BLYTHE ENERGY PROJECT

Request for Staff Approved Project Modifications (99-AFC-8C)

Southern California Edison's Blythe Eagle Mountain Transmission Line Pole Relocations and Modifications And Double-Circuiting 34 Structures to Accommodate Possible Future Solar Project

June 2009

Figure 2-1

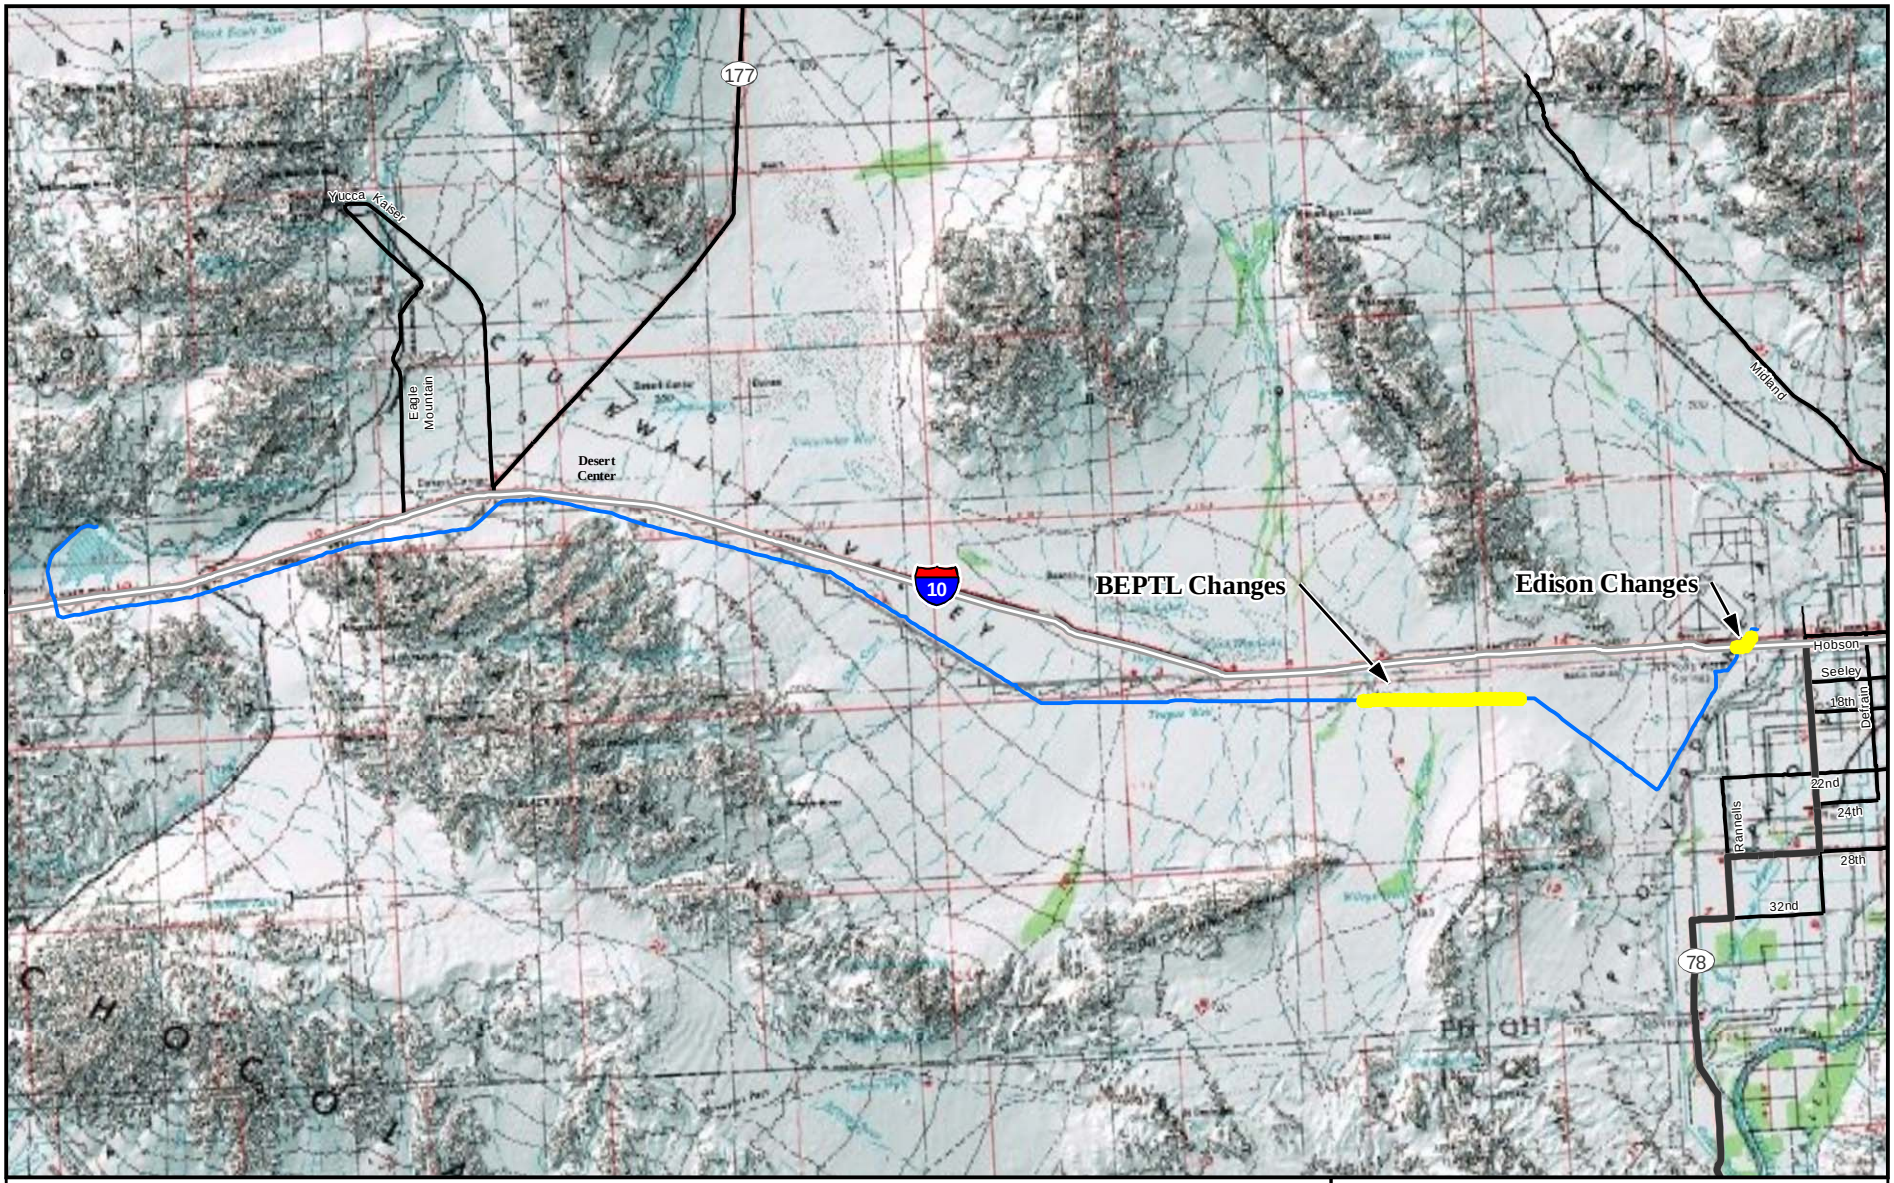
Figure 2-1 indicates the location of each of the minor project changes being discussed in this Request. Figure 2-2 illustrates the overall route and the location of the site-specific changes in the Edison structures and Figure 2-3 shows the location of the 34 poles to be replaced on the BEPTL line. Table 2-1 summarizes the change in disturbance footprint by proposed insignificant change component for the Edison structures. There will be no change in disturbance footprint to accommodate the BEPTL pole replacement. Table 2-2 details the change in underlying land ownership for the various project components between present conditions and proposed changes for the Edison structures, and Table 2-3 details the change in underlying land ownership that has occurred since 2005 along the 34-structure length of the BEPTL.

Figure 2-2

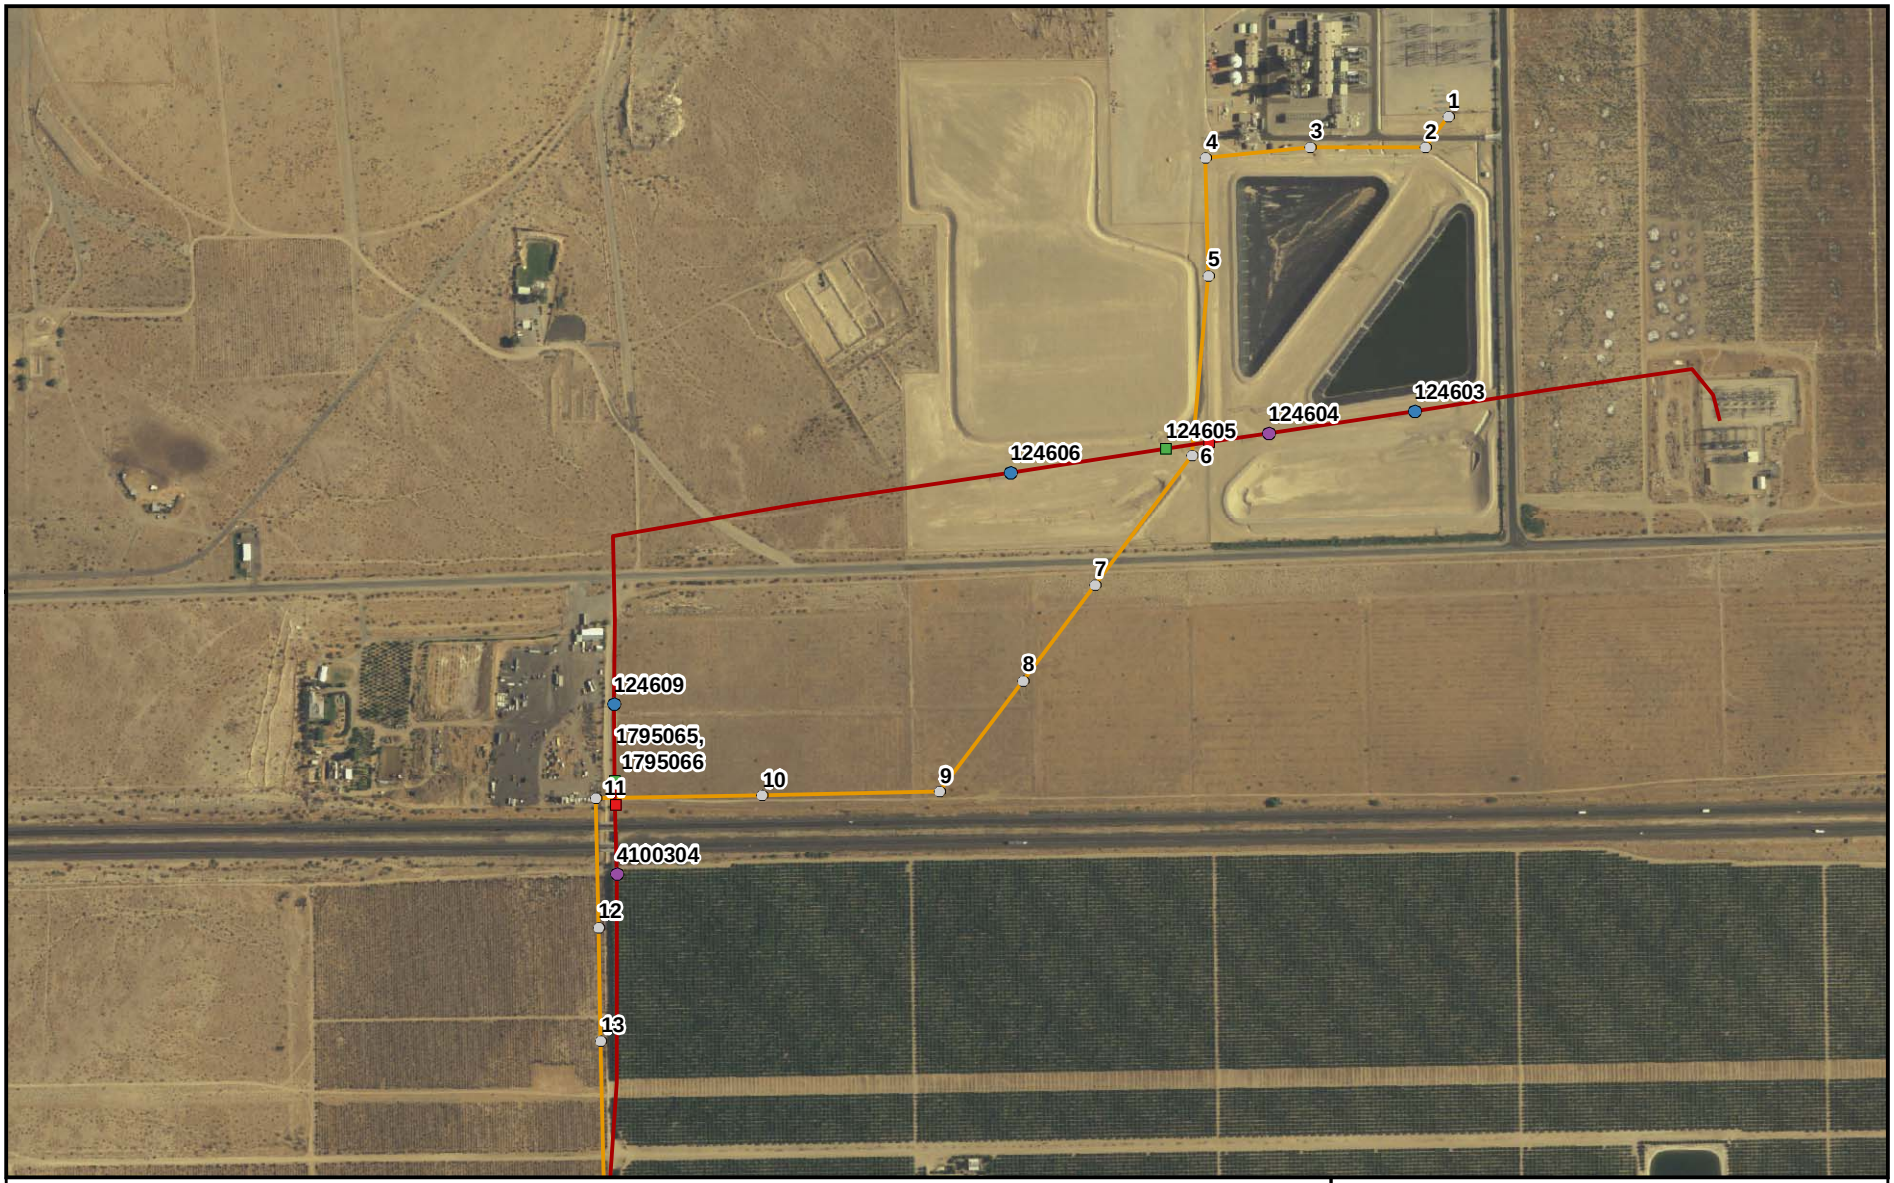
Figure 2-1 shows the present locations and proposed locations of structures 124605 and 179065E/1795066E of the B-EM transmission line to be relocated to accommodate crossing by the BEPTL. Appendix B details the structure changes and locations. Structure 124605 is currently located on the east side of the BEPTL just north of BEPTL structure 6, adjacent to the power plant property. It will be relocated approximately 190 feet to the west, on the existing alignment. The existing structure is a 90-foot wood pole H-frame with an above ground height of 79 feet. The replacement structure will be a 110-foot steel pole H-frame with an above ground height of 90 feet. This new structure will be supported by three way guys anchored 85 feet from the poles (west, north, and south) and a span guy on the east over the crossing of the BEPTL.

Due to the increased height of the replacement structure and line span at this location, structure support modifications at, or replacement of, adjacent structures will also be required (see description of support modifications below for details about structures). Suspension hardware at structures 124603 and 124606 will be replaced with dead ending hardware, and back and ahead guys will be added. New anchors will be installed for structure 124603 65 feet to the east and west of the pole. One new anchor will be installed for structure 124606 55 feet east of the pole; the existing anchor will be used on the west. The existing 90-foot wood pole H-frame structure 124604 will be replaced at its current location with a 95-foot steel pole H-frame structure. The existing three way guys will be used for support (north, east, and south) and a span guy will be used across the BEPTL crossing to structure 124605 to the west.

Structure 179065E/1795066E is currently located south of the BEPTL, just east of BEPTL structure 11, on the north side of the 1-10 freeway crossing. It will be relocated approximately 106 feet to the north, on the existing alignment. The existing structure is a 75-foot wood pole H-frame with an above ground height of 66 feet. The replacement structure will be a steel pole H-frame with an above ground height of 71 feet. The installation of taller structures at this location necessitates changing the suspension hardware on structure 124609 to the north to dead ending hardware, and adding ahead and back guy wires (55 feet from the poles to the north and south). Additionally, due to the increased line span at the freeway crossing, structure 4100304E will be replaced with a taller structure to accommodate sags under broken wire conditions. The taller

structure will be an 80-foot tall steel pole H-frame with an above ground height of 70 feet placed less than 4 feet from its current location. It will be supported with suspension hardware.

Figure 2-3

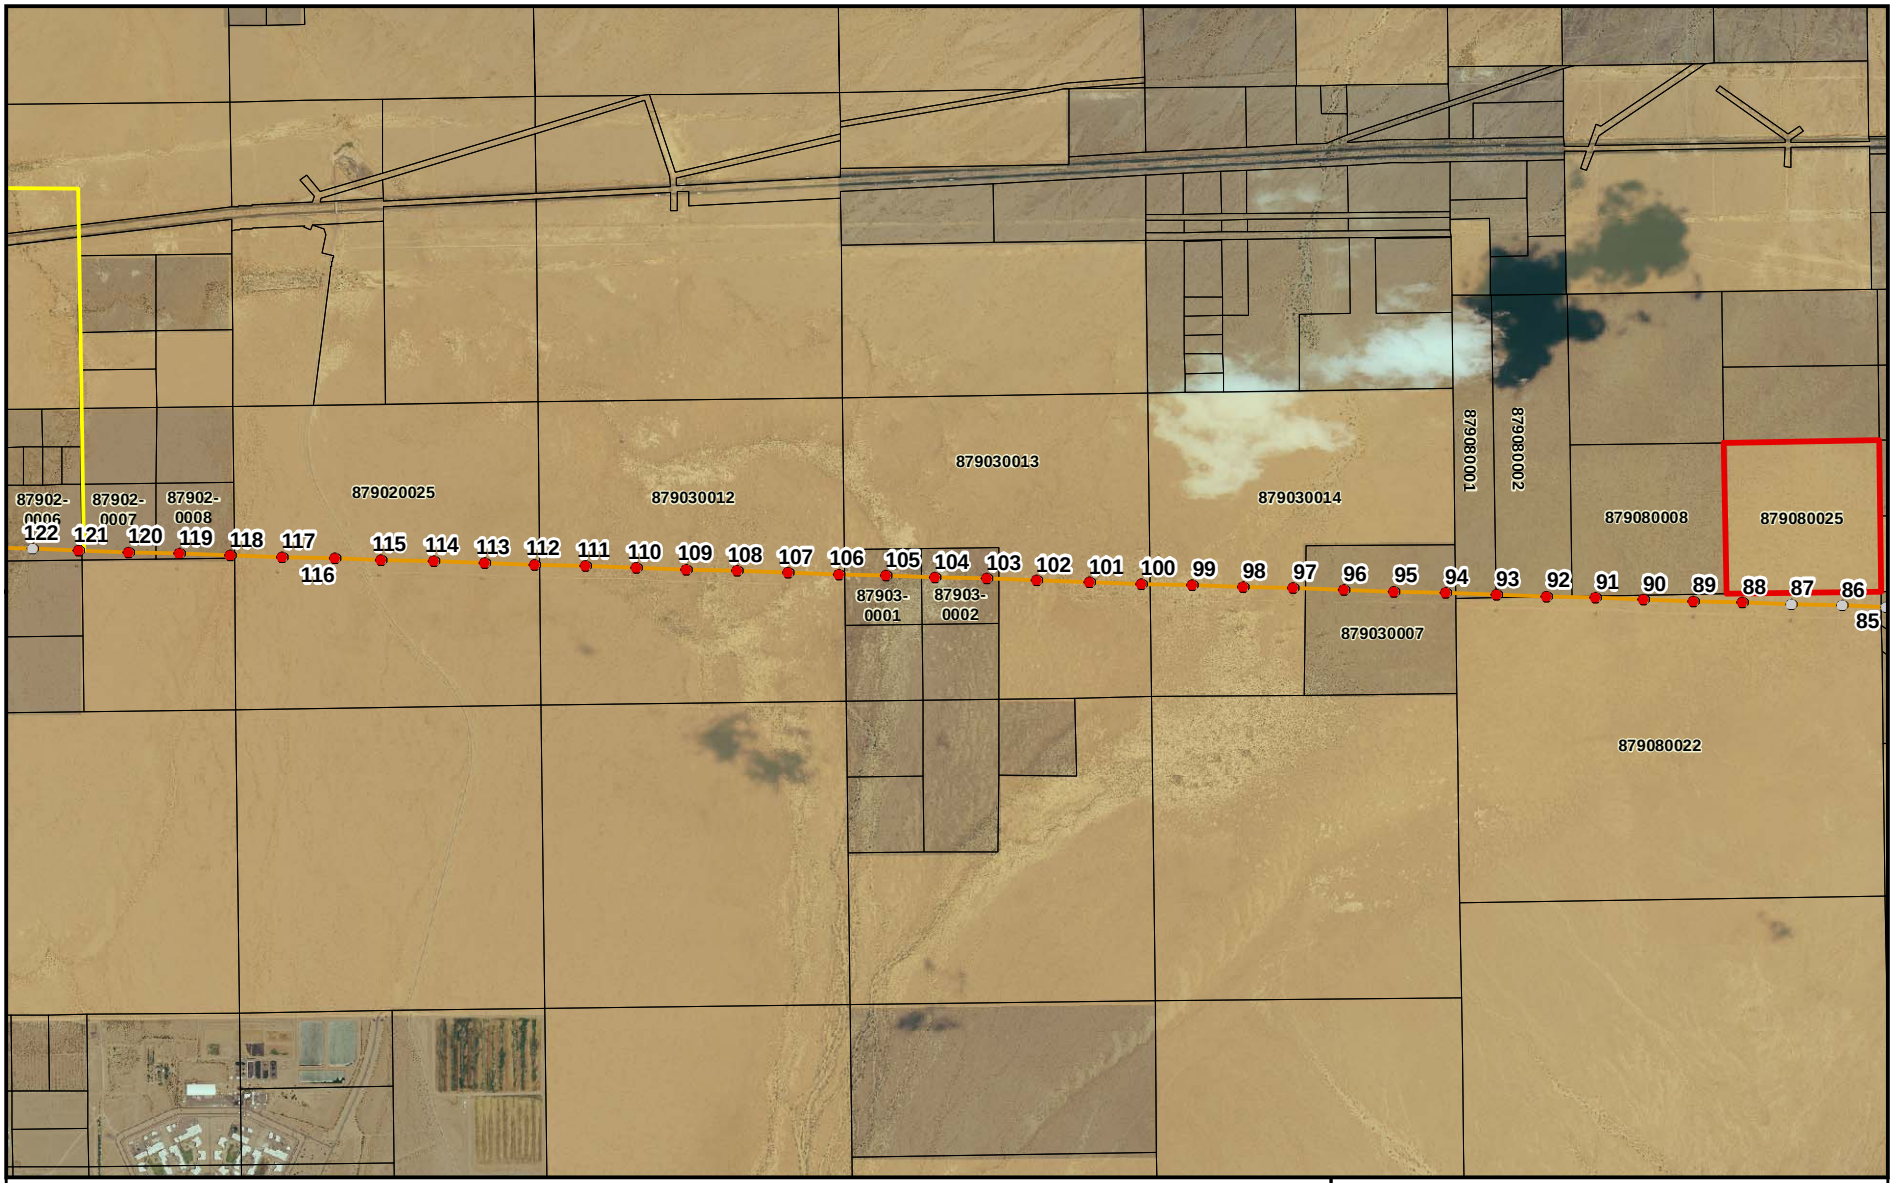
Figure 2-2 shows the locations of the BEPTL structures proposed for removal and replacement. Structures 88 through 121 cover 5.5 miles in a straight east-west line, with Project Genesis' proposed intertie line departing the BEPTL at structure 121 and heading northwest towards Ford Dry Lake. The existing structures are 105- to 115-foot concrete poles with an above ground height of 88 to 102 feet. The replacement structures will be a 125 to 130-foot double circuit concrete pole with an above ground height of 105 feet. These new structures will be self-supporting, direct-embed poles, please see Figure 2-4 for a comparison of the structures.

Figure 2-4. Comparison of Existing and Replacement Structures.

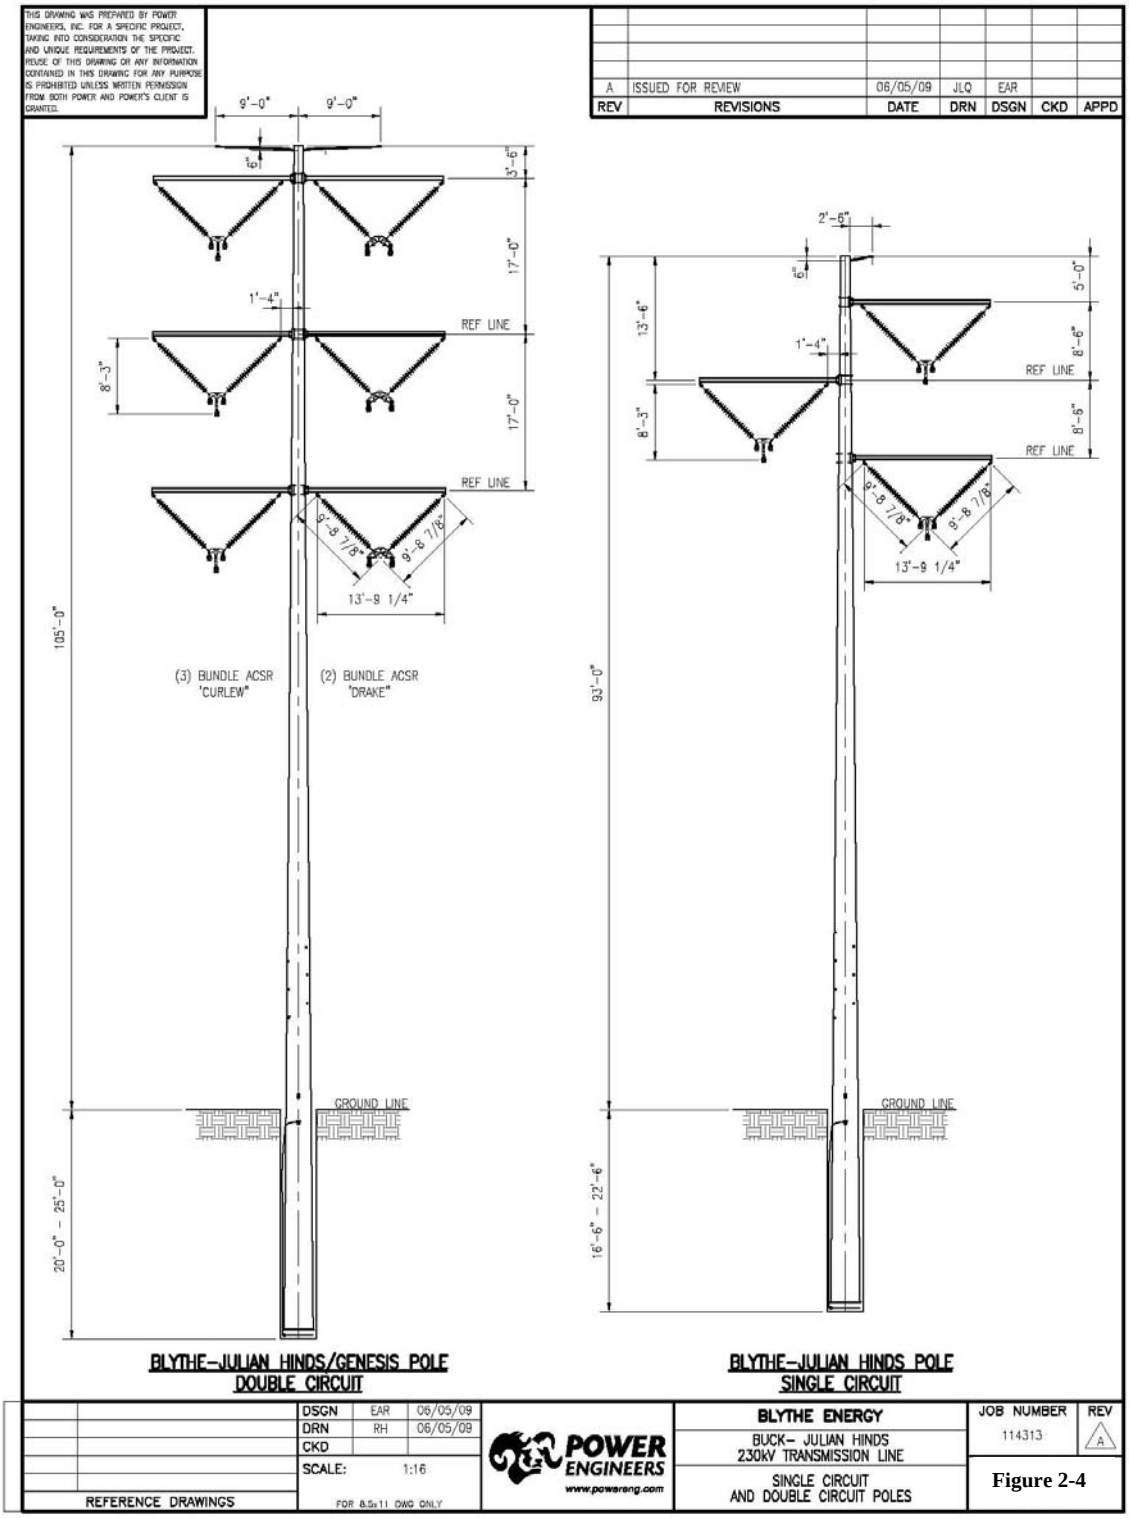
The BEPTL is presently configured as a single-circuit 230kV transmission line using concrete or steel monopoles to support the three phases in a ‘Delta’ configuration. The BEPTL is under

construction now and all 34 poles proposed for replacement have already been installed. These poles would be replaced with similar poles, but taller and stouter, that could accommodate two 230kV circuits.
